**DATE:** 11.09.2018  
**TO:** ProTrak  
**FROM:** Mitesh Baxi  
Traffic Engineering

■ **RIVERLIGHTS CONVENTIONAL PH V & VI [Subdivision Plan Review #3]**

# Riverlights Conventional Ph 5 & 6 Standard Street Lighting Plan

**OVERALL SITE PLAN**

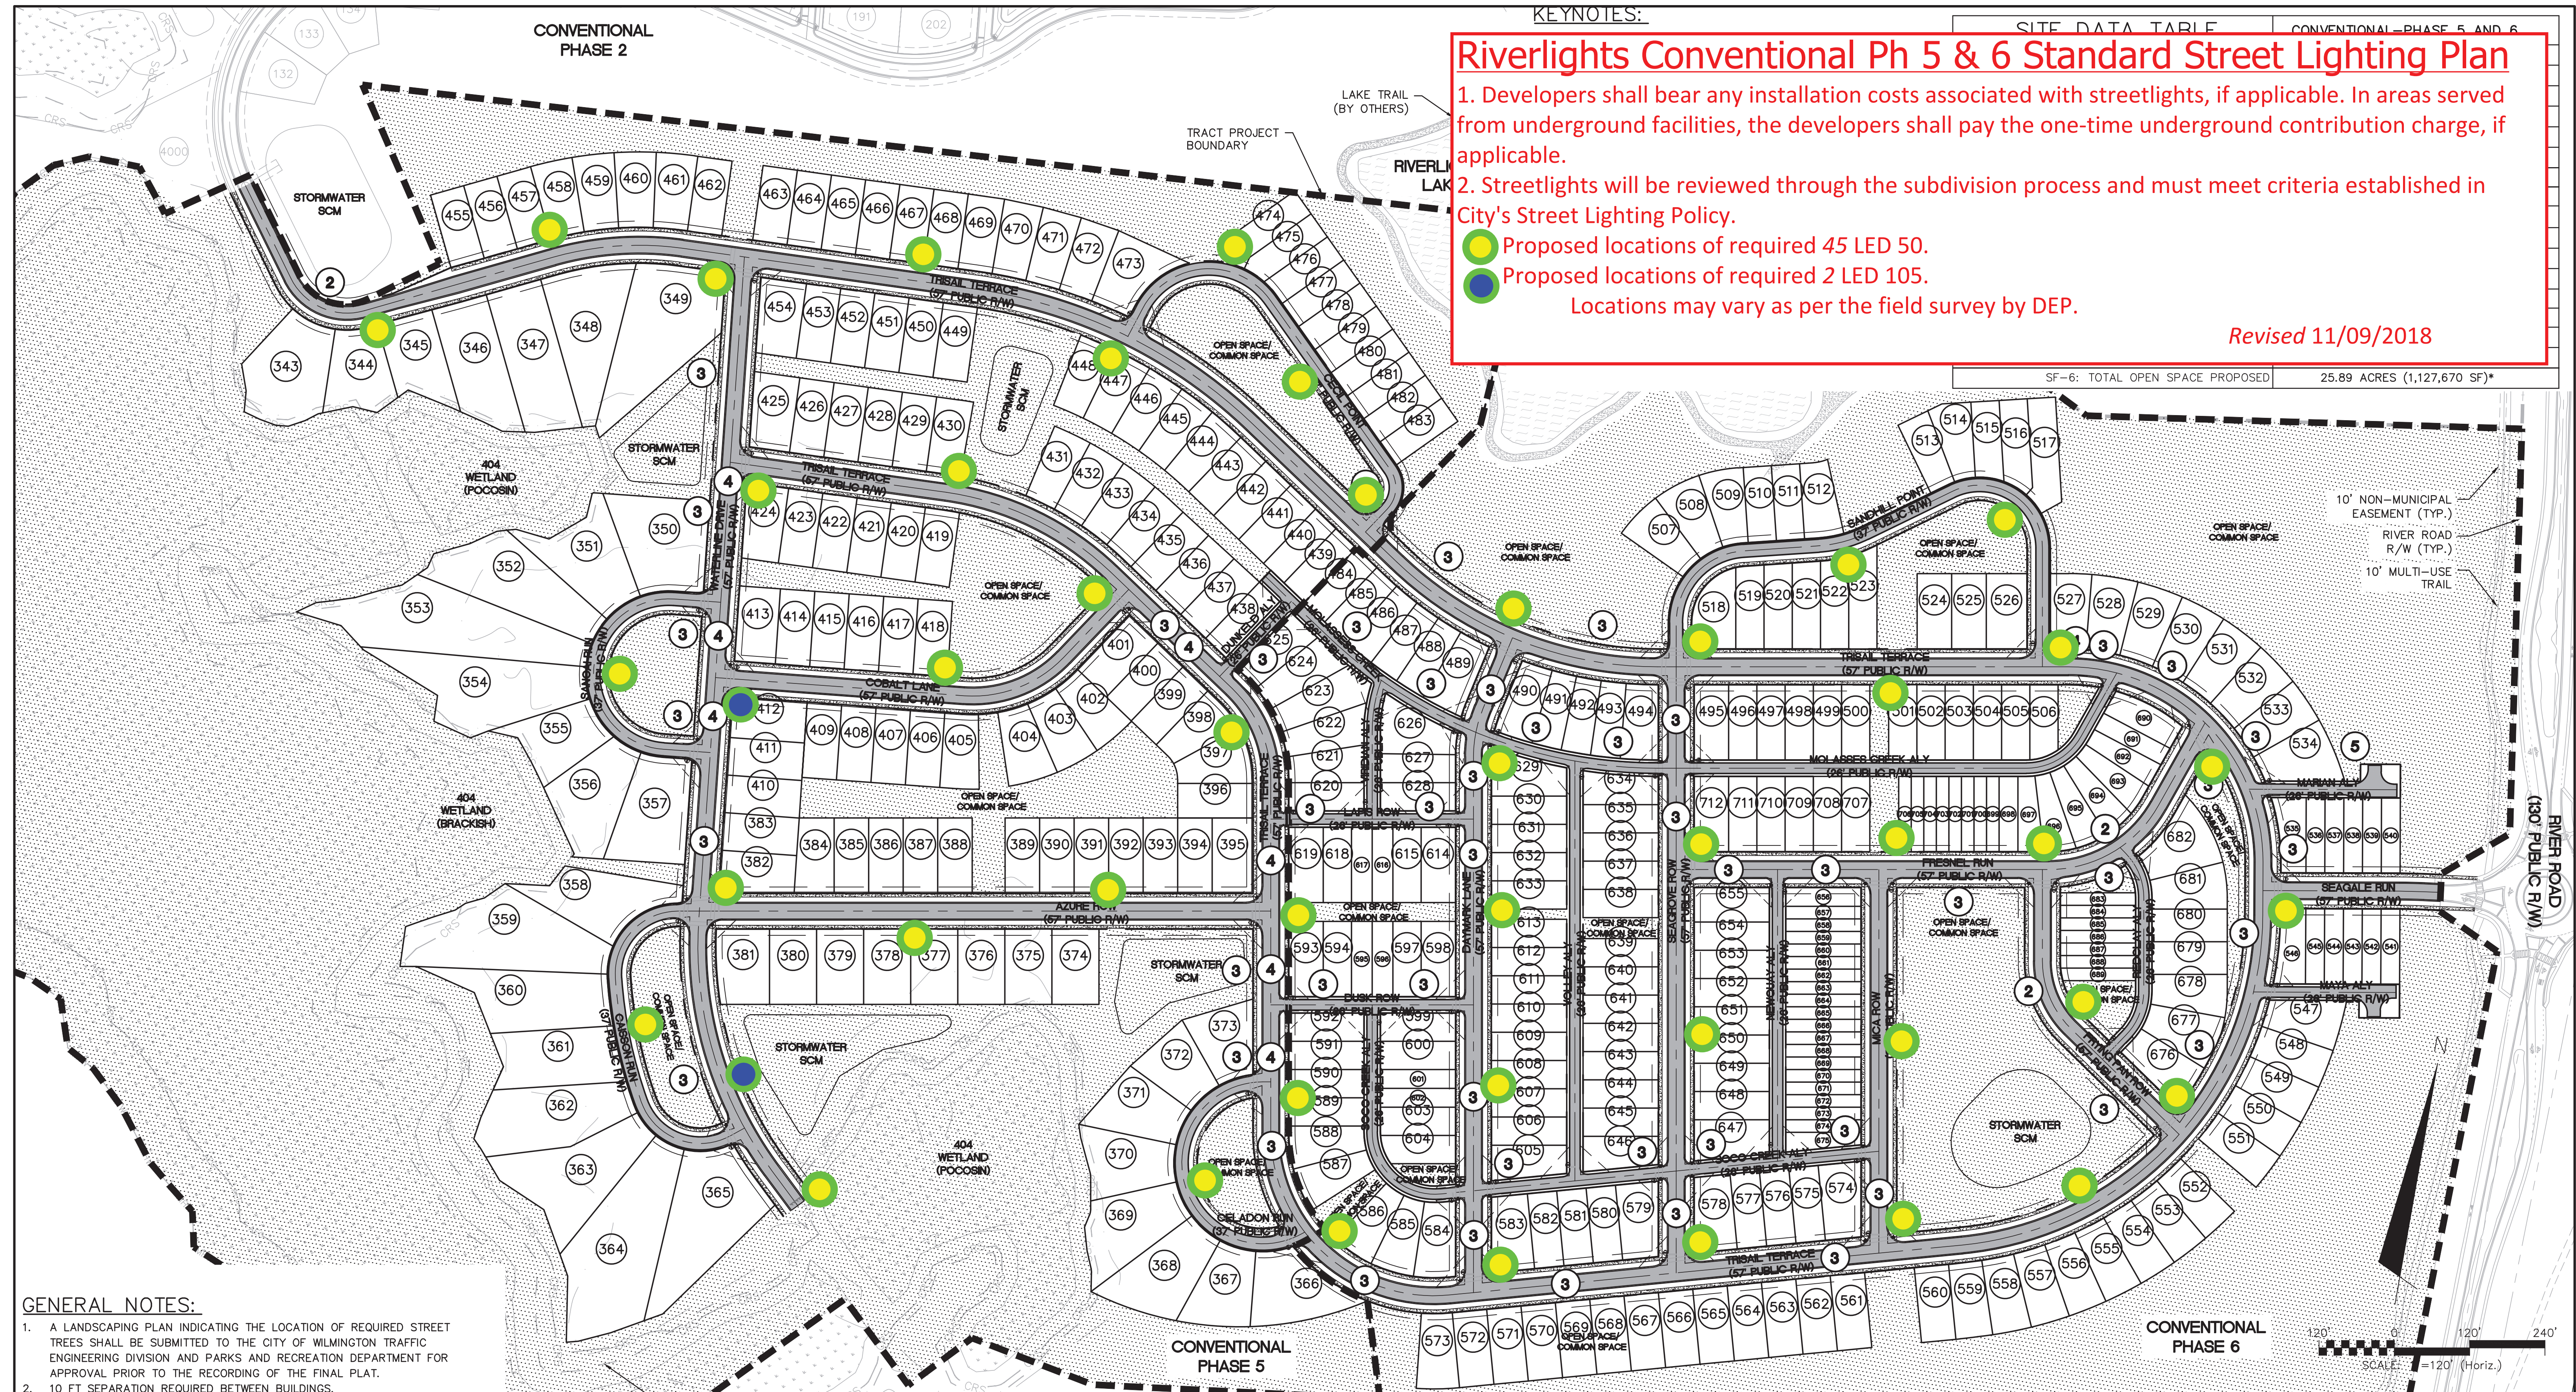
2. A layout for the Standard street lighting has been provided with the review. Minimum of 47 (forty seven) street lights are required for this sub-division. 45 LED 50's and two LED 105's will be required. Although, developers may choose to provide any extra lights or ornamental. Any installations above the criteria of Standard street lighting, will be considered as non-standard and has to conform to the City's non-standard street lighting procedure as per the policy.

- Proposed locations of required 45 LED 50.
  - Proposed locations of required 2 LED 105.
- Locations may vary as per the field survey by DEP.
